REFERENCE NO: RF-23-01

DATE: 01/23/2023

SUBJECT: Oil Galley Plug

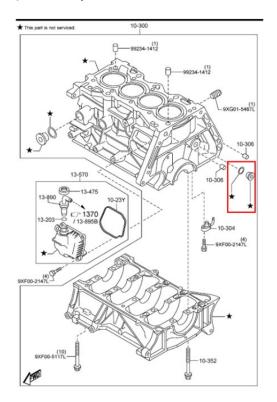
When servicing SKYACTIV engine vehicles requiring to replace the Oil Galley Plug and Crush Washer, order the required part numbers below. These parts are not listed in GEPC and were previously listed as "non-serviceable" in the cylinder block diagram.

Part Number	Description	Qty	Notes
P301-10-327A	PLUG, BLIND	1	Torque spec. 56.9 to 68.8 N/m
9956-22-000	GASKET	1
